Staff Report – Plan Commission

Docket #:	PC2024-018	Hearing Date:	August 12, 2024
Applicant:	Chris Strack, SCS Construction Services, 173 E. Broadway St, Ste. 100, Greenwood		
Owner:	CJS Greenwood, LLC, 200 S. Biscayne Blvd. FL 7, Miami, FL 33131		
Subject Property:	532 N. State Road 135, Greenwood		
Staff Contact:	Gabe Nelson, nelsong@greenwood.in.gov, 317.887.5230

Jiffy Lube requests a site development waiver from Sec 10-06-09 (A) – Required sidewalks in subdivisions. A 6-foot sidewalk is required in and along commercial subdivisions. Petitioner requests to waive the sidewalk requirement only along State Road 135. Sidewalk will be installed along W. Fairview Road.

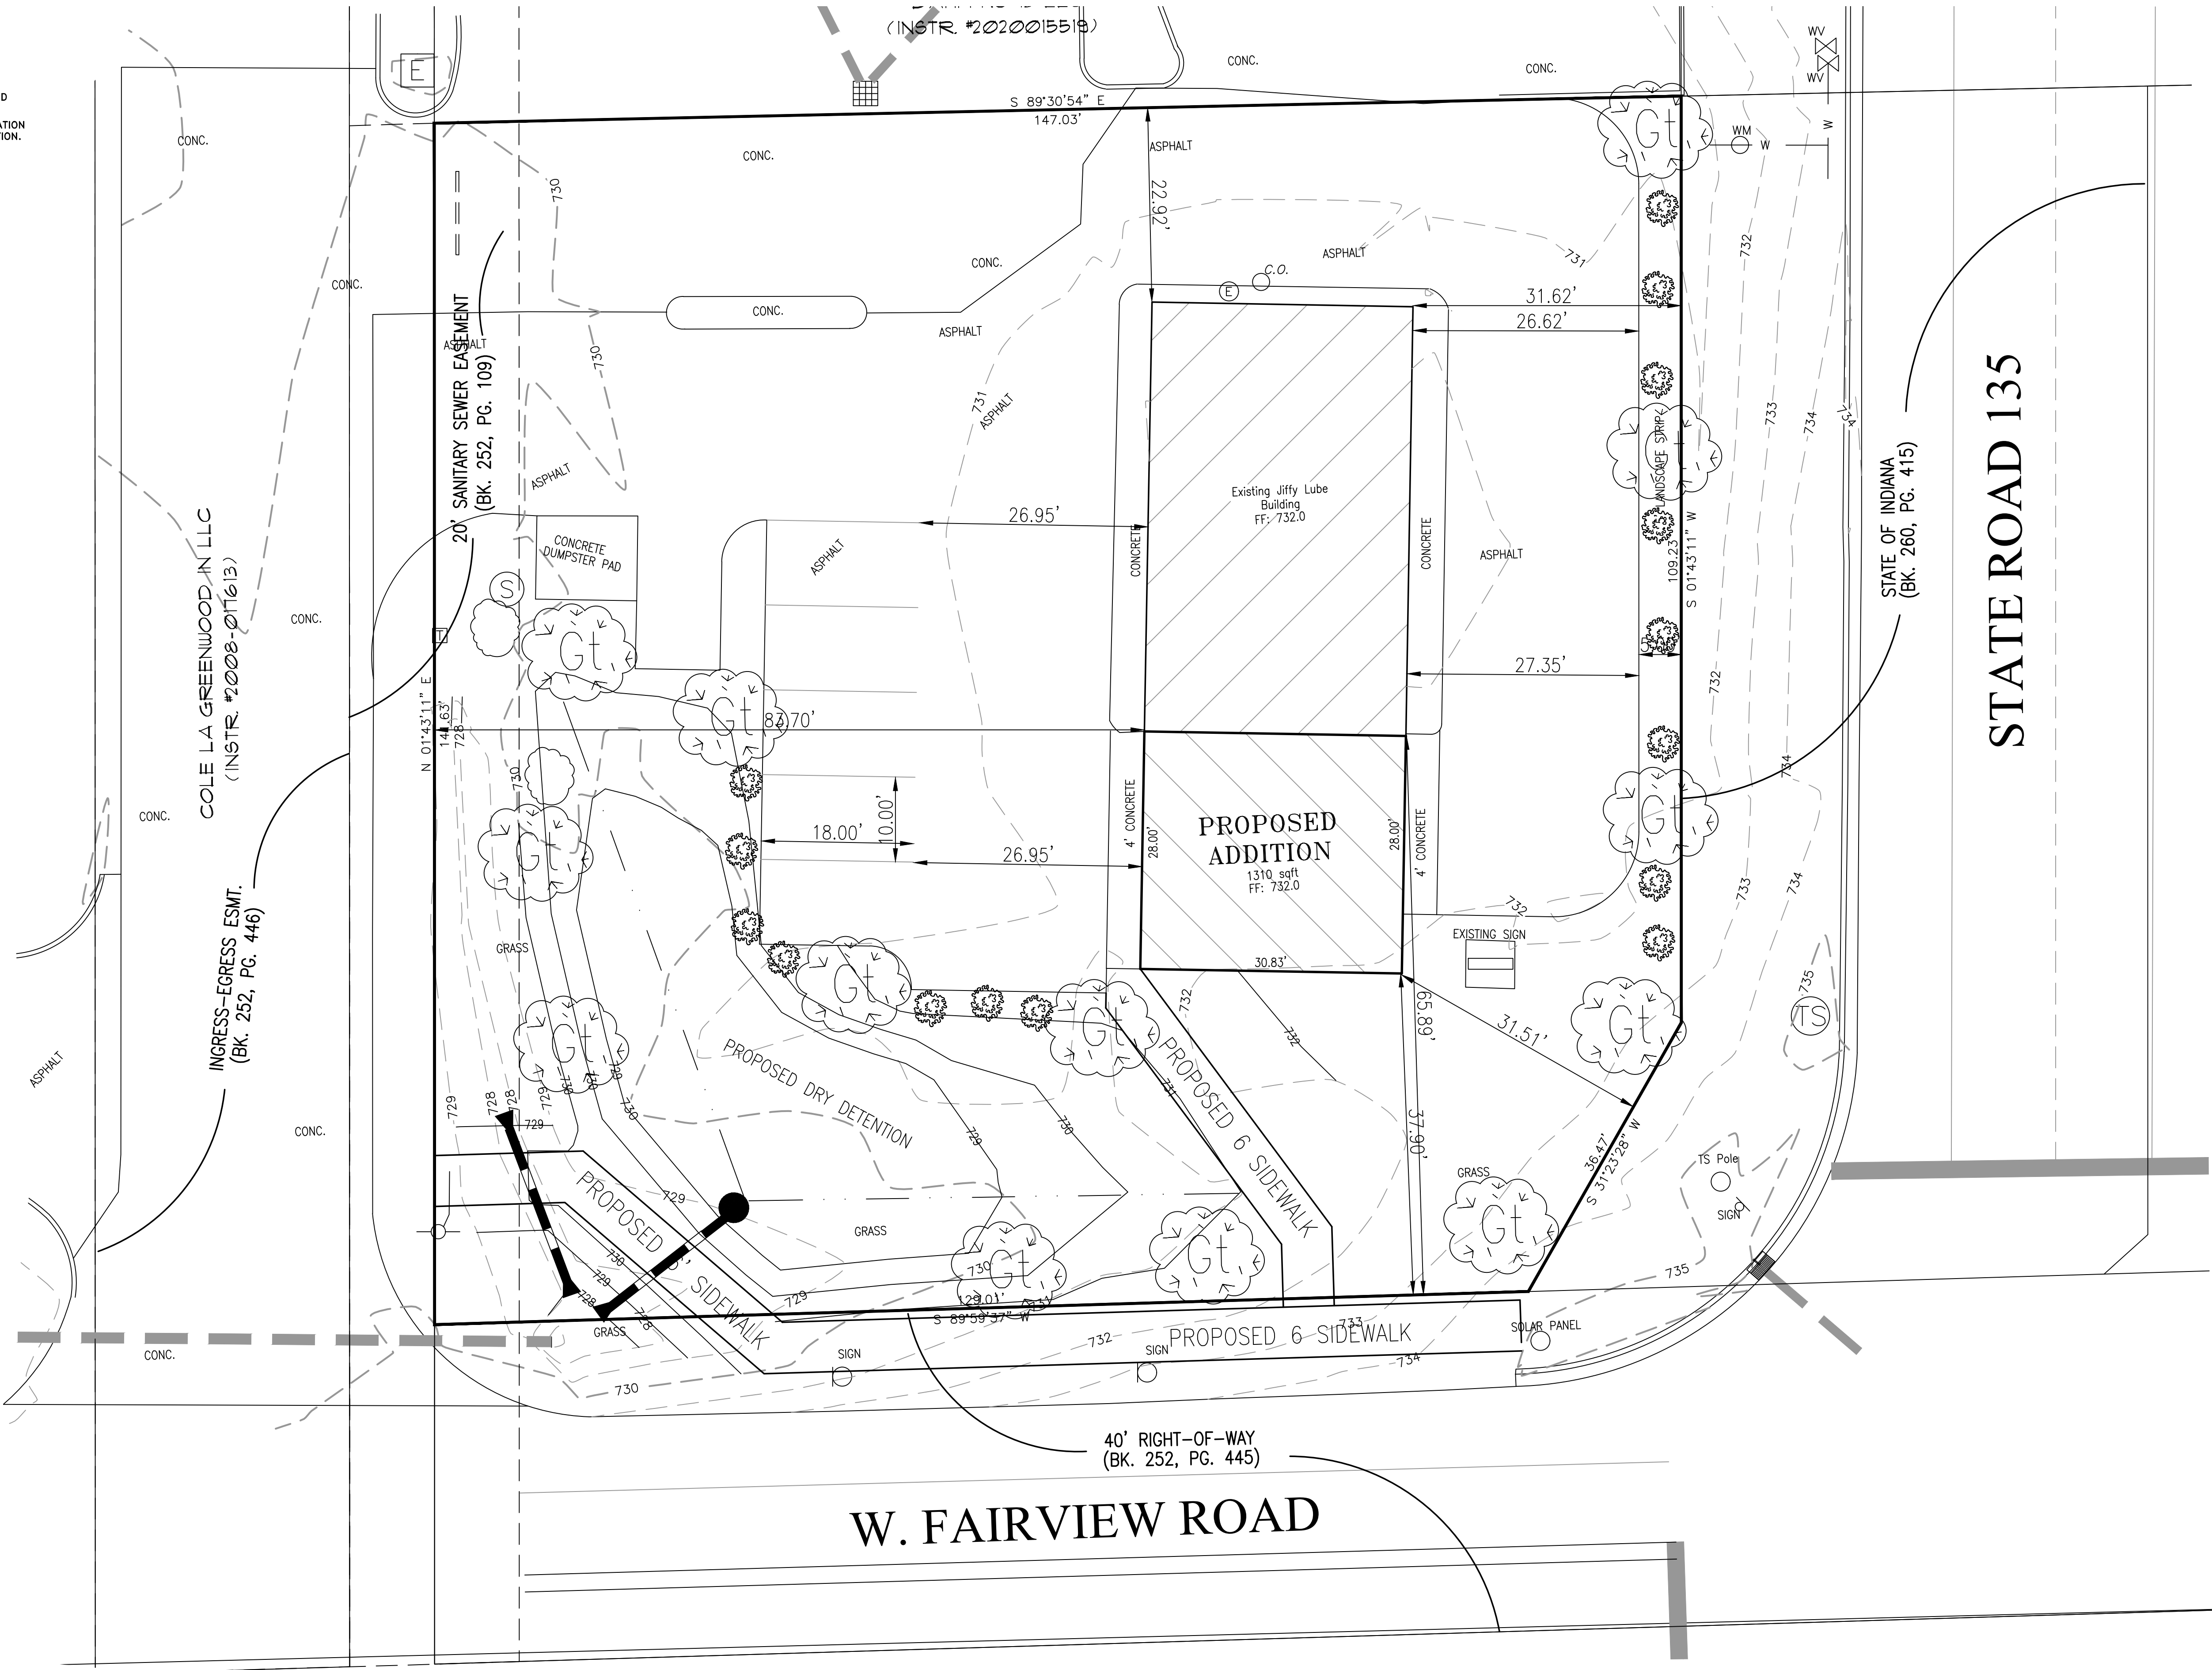
Staff **recommends denial** of Sec 10-06-09 (A) – Required sidewalks in subdivisions. It would be preferred for the sidewalk to be placed in right-of-way, but this particular right-of-way is controlled by INDOT and they are refusing a sidewalk be placed there. The petitioner has provided a revised sketch showing a reduced landscape strip with a 5-foot sidewalk that may still cause larger vehicles to enter a portion of the sidewalk.

While Staff is understanding of this potential conflict, staff also believes that an option to construct a sidewalk with a roll curb or similar type configuration will allow the sidewalk to be built and allow for larger vehicles to exit the building safely. Although not an ideal situation with vehicles occasionally driving over a portion of the sidewalk, they will be doing so at a very slow rate of speed and would not cause any danger to pedestrians. It is Greenwood's goal and desire to provide a trail and/or sidewalk along the entirety of SR 135. A sidewalk at this particular location fill in a key gap in this desired pedestrian system.

The proposed plans show a minimum of 26.6 feet for traffic exiting the building which would still leave sufficient room for the overwhelming majority of vehicles serviced at this location. The City Engineer may reduce the width of the sidewalk due to slope, grade, topography, or other restrictions encountered in the field if space is a concern.
